City of  
**Peterborough**

**Subject:** **Report USDIR17-003  
Streetscape and Public Realm for Bethune Street from  
Townsend Street to Dublin Street – Update Report**

Figure 3 - Bethunescape: Hunter Street to Murray Street Design  
(Alternate/ Refined Design)

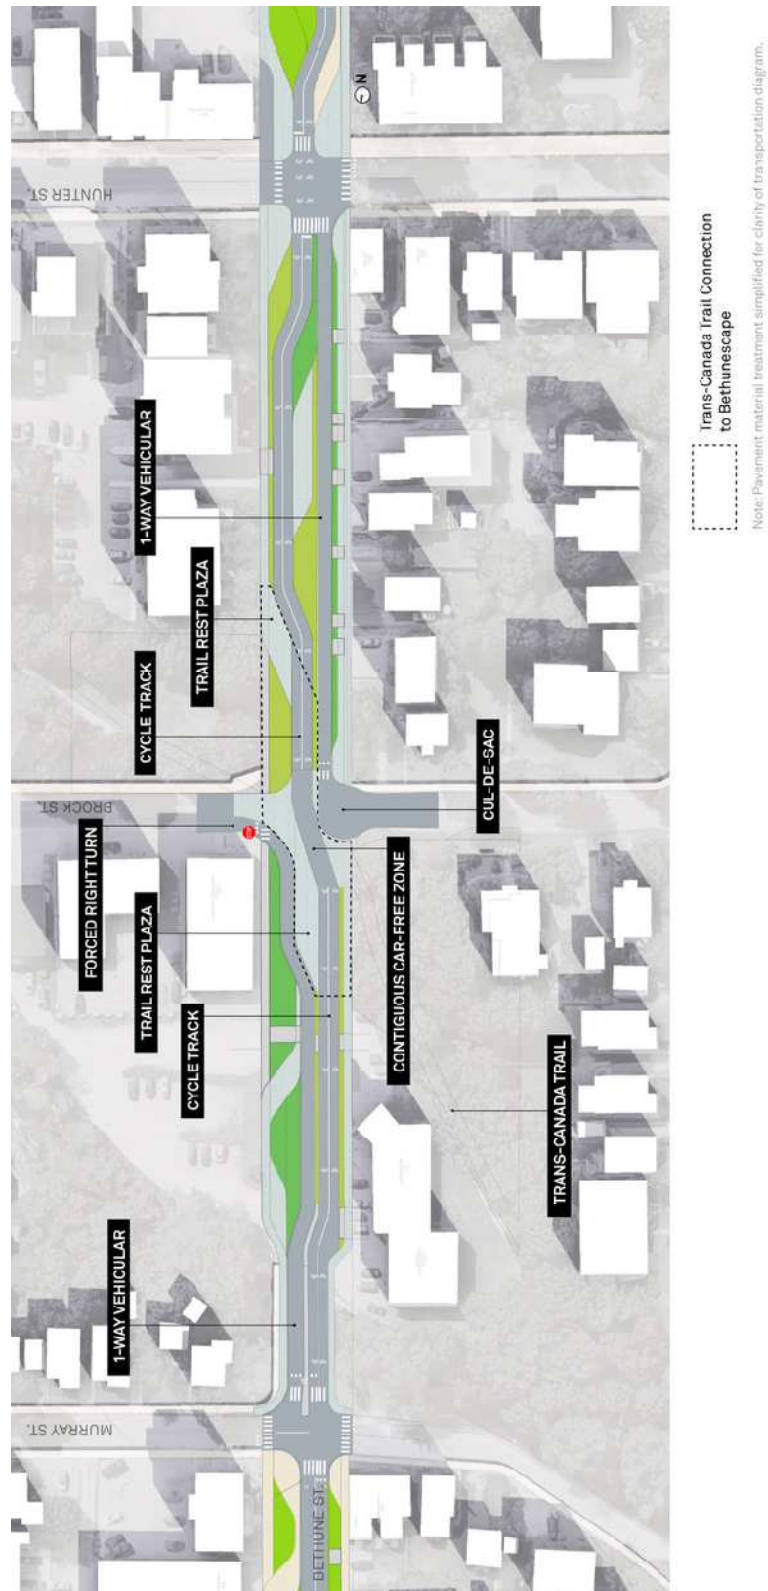
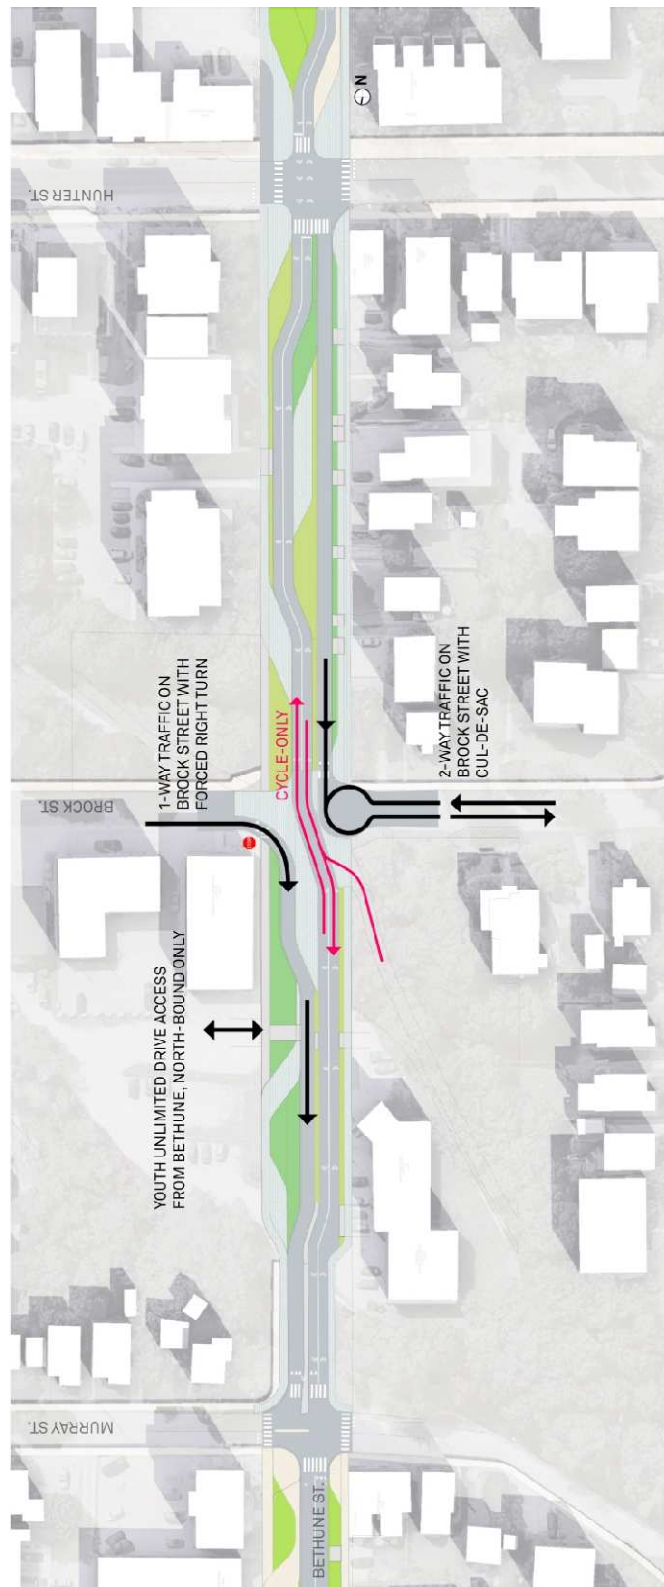
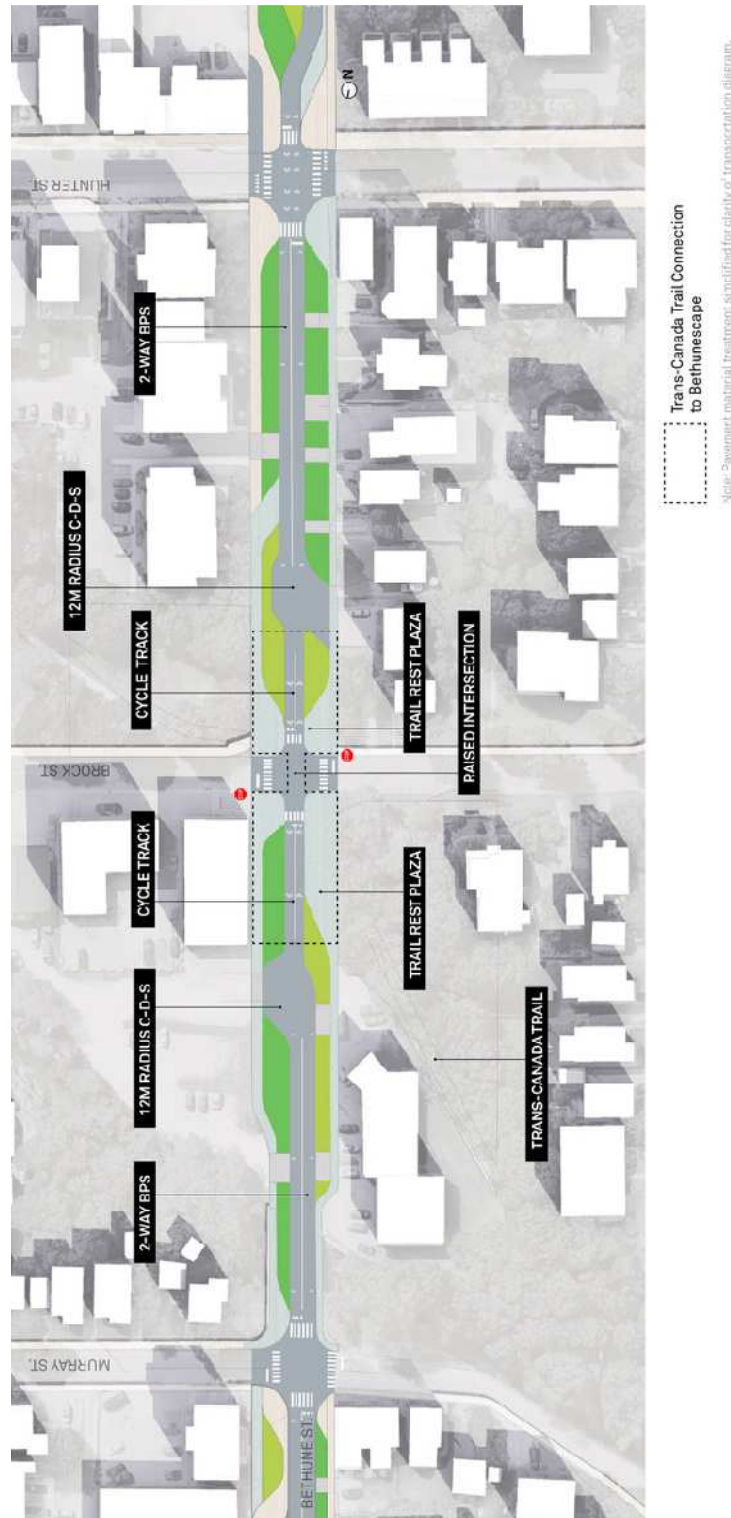
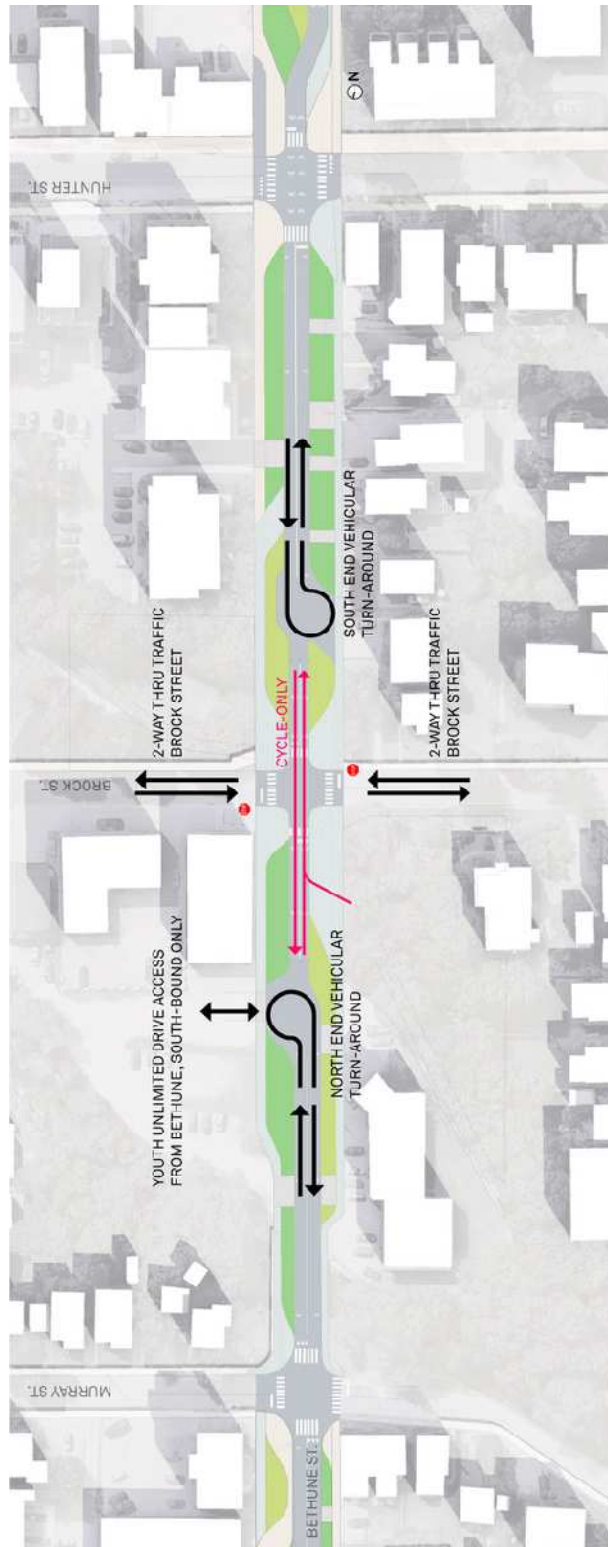
Hutchison House representatives, in particular, expressed concerns with the original design proposal because they wanted continuous east-west through traffic along Brock Street. Their concerns would necessitate a change in the original design.

Youth Unlimited representatives, however, voiced concerns related to the reduced access to their parking lot/area from Brock Street. Consequently, further minor refinements to Bethunescape were made and staff now believe the alternate/refined design as depicted in Figure 3 (Bethunescape: Hunter Street to Murray Street Design) and Figure 4 (Bethunescape: Hunter Street to Murray Street Movement Flow) generally satisfies all stakeholder concerns.

The alternate/refined design developed for the section of Bethune Street from Hunter Street to Murray Street, revised the traffic flow along both Brock Street and Bethune Street. In response to access concerns, the revised design now allows traffic along

Brock Street to continue in both the easterly and westerly directions. To maintain the “park-like” pedestrian and cyclist friendly conditions along Bethune Street, north- and south-bound vehicular traffic on Bethune Street will no longer be able to access Brock Street.

This alternate/refined design lessens somewhat, the establishment of a complete "linear park-like" atmosphere as compared to the original design. However, the alternate/refined design does mitigate confusion that may have arisen for all users at this location. This is particularly the case at the Bethune Street/Murray Street intersection where movements for all users has been simplified – a development that mitigates potential conflicts between different users. A comparison of the characteristics of the original with the alternate/refined design for Bethune Street between Hunter Street and Murray Street is shown in Table 2.

- a) That the alternate/refined design to Bethune Street between Murray Street and Hunter Street, inclusive of the Bethune Street/Brock Street intersection, as shown in Figures 3 and 4 of Report USDIR17-003 be adopted;
- b) That the original design to Bethune Street between Simcoe Street and King Street, inclusive of the Bethune Street/Charlotte Street intersection as recommended in Report USDIR16-012 and reported to Council on November 14, 2016 be adopted;
- c) That undergrounding of the electrical distribution system on Bethune Street from Townsend Street to Dublin Street not be undertaken as part of the Bethunescape Project; and
